From: "Bunnell, Mark" <MBunnell@archcoal.com>
To: "Priscilla Burton" <priscillaburton@utah.gov>
Date: 3/30/2006 12:03:15 PM
Subject: RE: Task 2390

Attached are revised pages 9-13 which include the following revisions I have discussed with you and Pete:

From: Priscilla Burton [mailto:priscillaburton@utah.gov]
Sent: Wednesday, March 29, 2006 3:50 PM
To: Bunnell, Mark
Cc: Pete Hess; Wayne Hedberg
Subject: RE: Task 2390

Figure 1. Typical drillpad construction and setup.

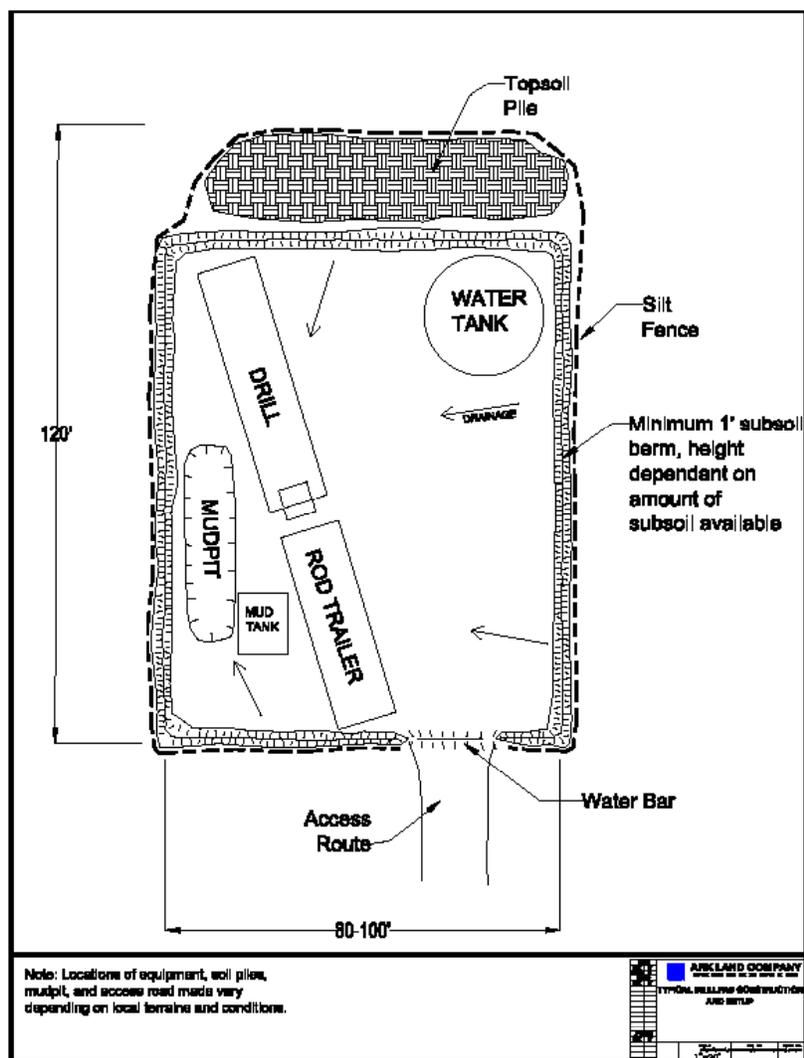
Page 11, Fig. 1: Altered to include silt fence around entire disturbed area including topsoil pile. Size of disturbance increased to 100 X 120'. Berm to be constructed of subsoil material.

Drillpads will be constructed at sites A-05 and B-05 (Map 2). Drillpads will be approx. 100 ft. X 120 ft. and will include a mudpit approx. 40 ft. long, 10 ft. wide, and 8 ft. deep. Topsoil "A" horizon will be removed and stockpiled for reclamation. A separate stockpile will be created for material below the "A" horizon if necessary to make a level drillsite and to store material excavated from the mudpit. A qualified individual will be present at the site during construction to identify the topsoil horizon and direct material salvage. A 1 to 3 ft. berm will be constructed around the perimeter of the pad to ensure no runoff from the pad. The pad will be constructed such that fluids will drain toward the mudpit. Mudpits will be lined. Figure 1 shows a sketch of the planned drillpads. The only materials disposed of at the the drillsites will be cuttings, excess drill core, and used drill foam/mud which will be placed in the mudpits and buried at a depth greater than 4 ft. The pit liner will be removed and hauled away. No drilling fluids, oil and grease, or diesel fuel will be allowed to contact the topsoil. Mudpits will be pumped out and/or allowed to dry before being reclaimed. Pumped fluids will be transported to an approved disposal site off USFS lands. Mudpits will be fenced when unattended to prevent wildlife from possible entry.
